Product hierarchy no. *				Part no.	SBU	Type / Description	Customer part no.
SBU	PG	PUG	Type				
02	007	012	0000002288	See list below	Appliance inlet	4788

Change of marking.

Product Change Notification					PCN 4788		D10-012-705
owner	creation date	release date	released by	change order no	rev	page	
hotzar	2017-01-16	2017-02-08	buerglal	2011292	A	1 of 1

Old product appearance	New product appearance

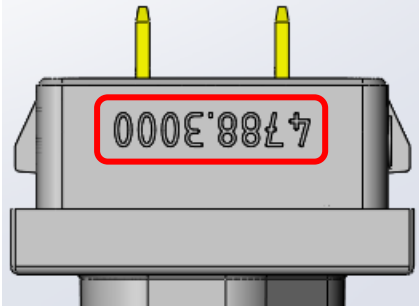
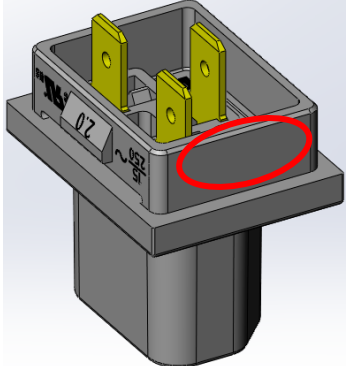
The part number is no longer printed on the product.
